**STATE OF CONNECTICUT
CONNECTICUT SITING COUNCIL**

IN RE: :
 :
 : DOCKET NO. 510
 :
 NEW CINGULAR WIRELESS PCS, LLC :
 D/B/A AT&T AND TARPON TOWERS II, :
 LLC APPLICATION FOR A CERTIFICATE :
 OF ENVIRONMENTAL COMPATIBILITY :
 AND PUBLIC NEED FOR THE :
 CONSTRUCTION, MAINTENANCE AND :
 OPERATION OF A :
 TELECOMMUNICATIONS FACILITY : August 1, 2022
 LOCATED AT 92 GREENS FARMS ROAD,
 WESTPORT, CONNECTICUT

**NEW CINGULAR WIRELESS PCS, LLC D/B/A AT&T AND TARPON
TOWERS II, LLC RESPONSES TO CONNECTICUT SITING COUNCIL
PRE-HEARING INTERROGATORIES DATED JULY 8, 2022**

Existing Coverage
2300 MHz LTE

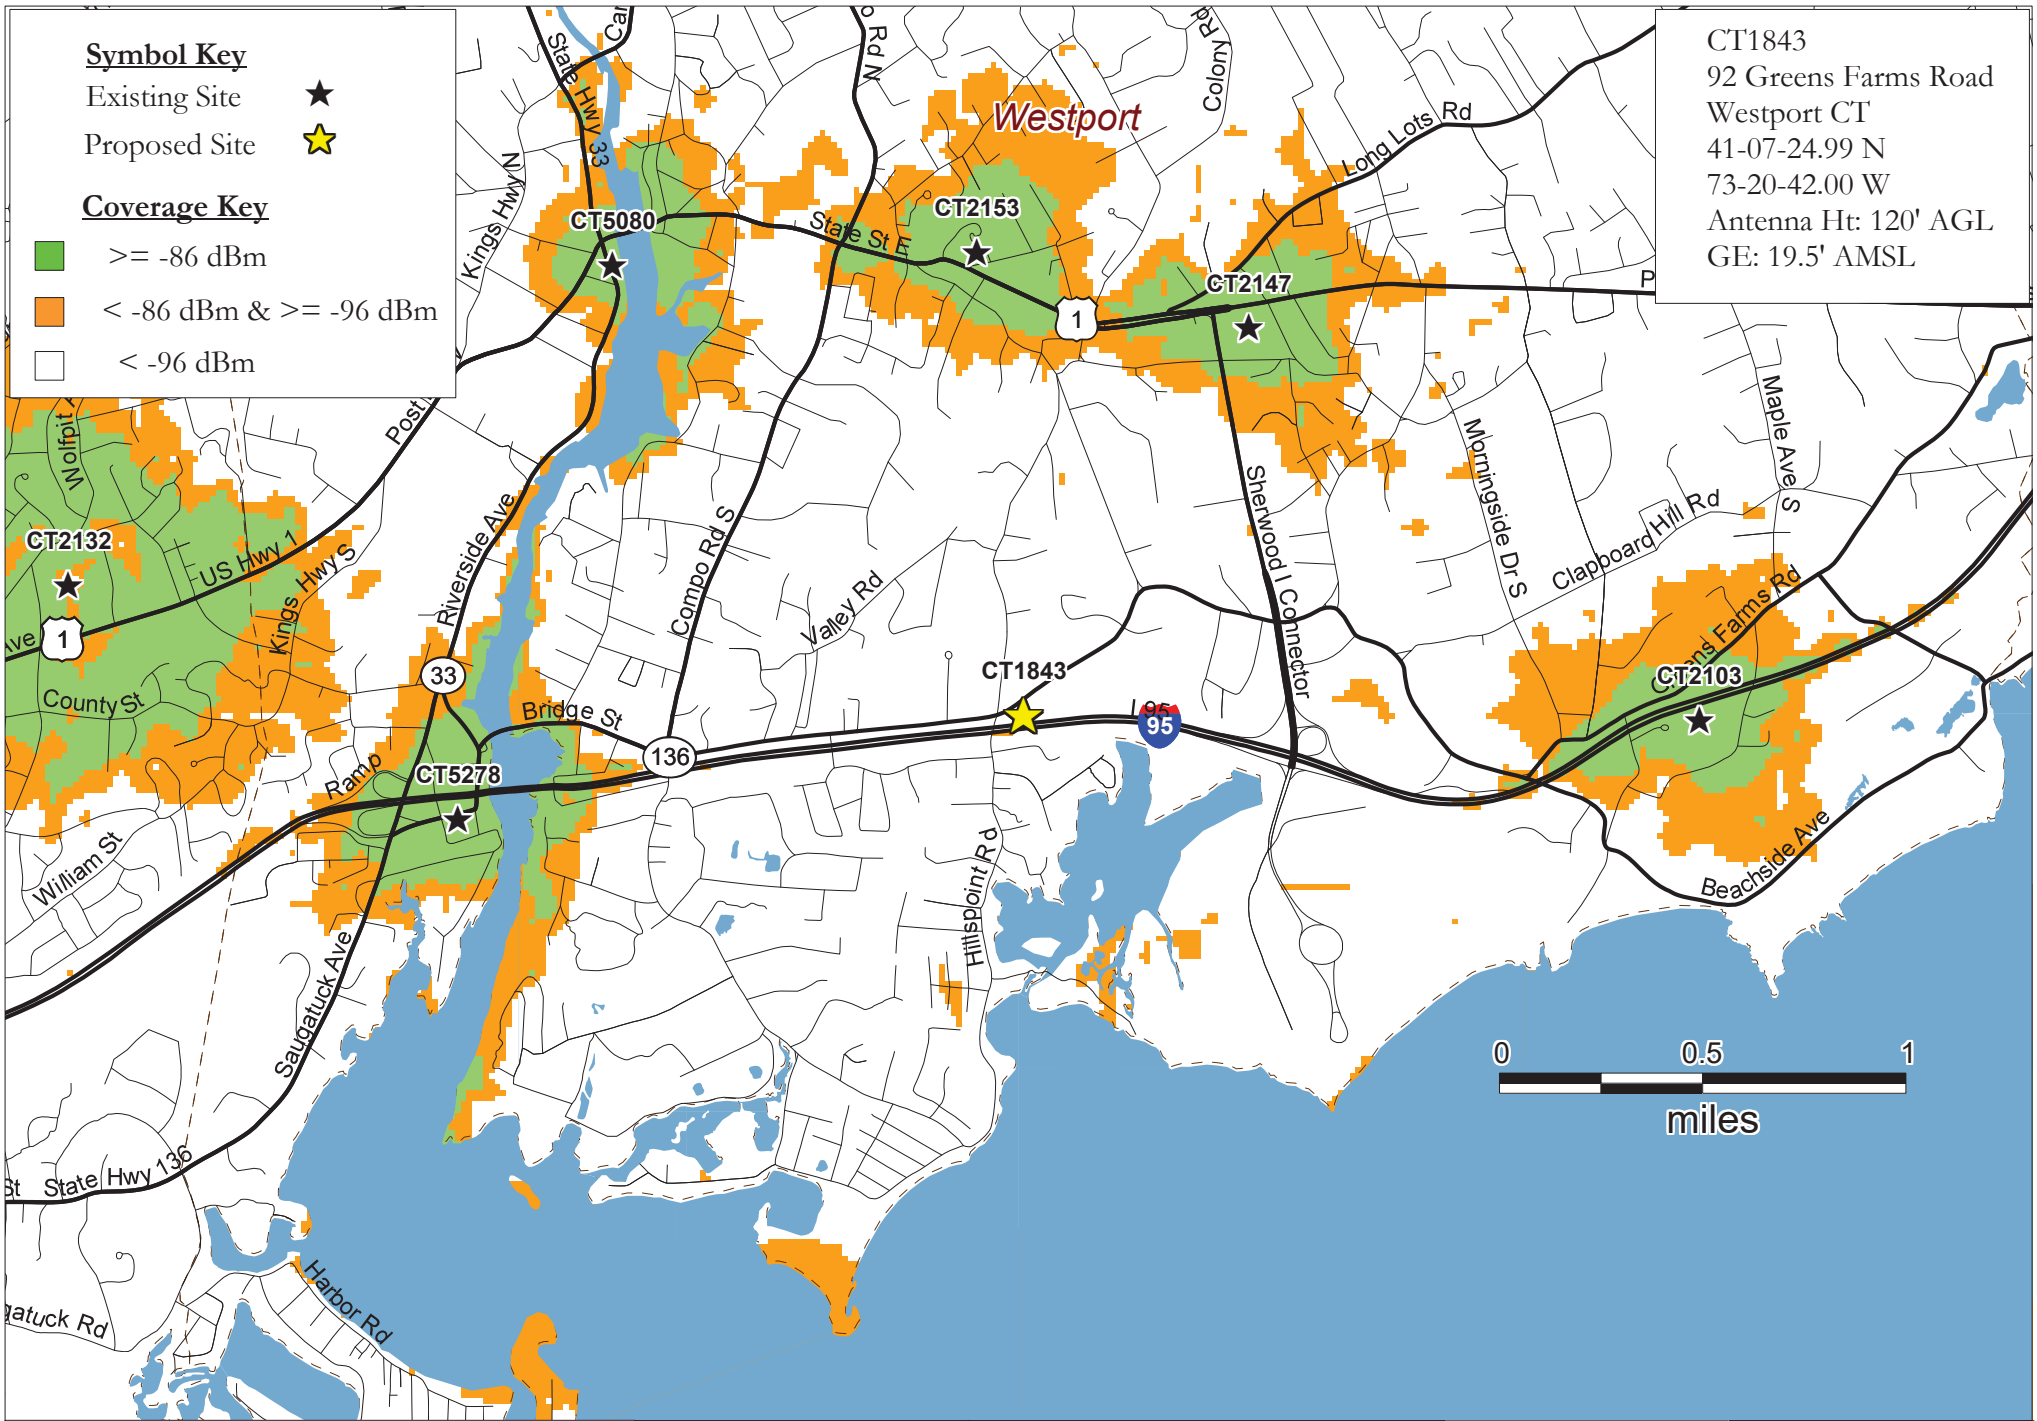
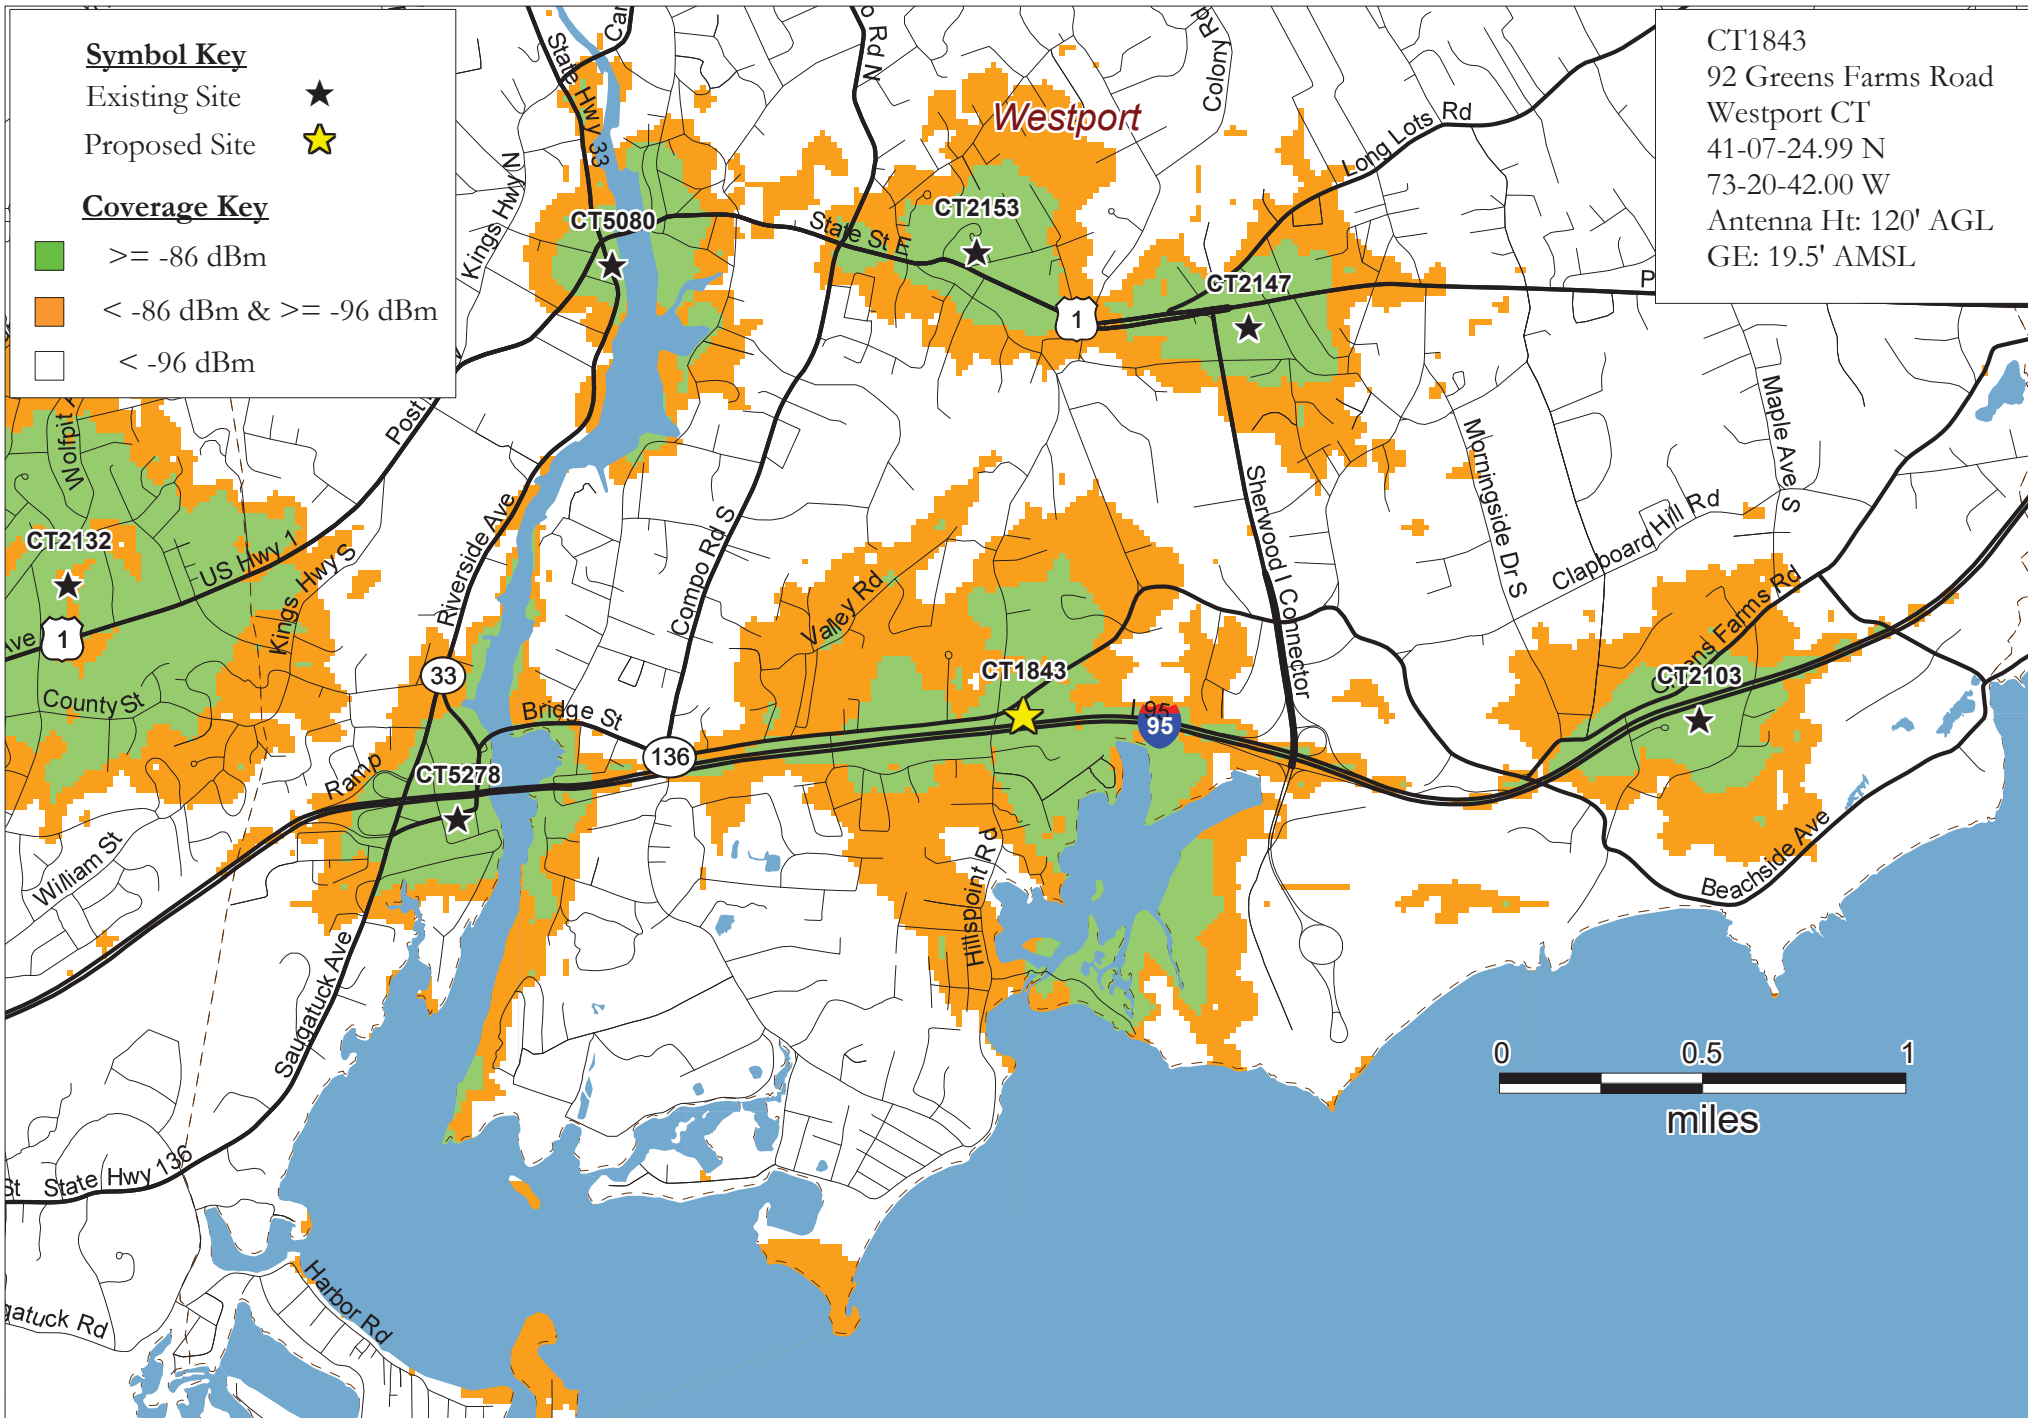
35. What is AT&T's existing and predicted coverage footprint from the proposed site (in square miles), at each frequency that would be installed?

Please see the coverage plots included in Exhibit 28. The predicted coverage footprints are as follows:
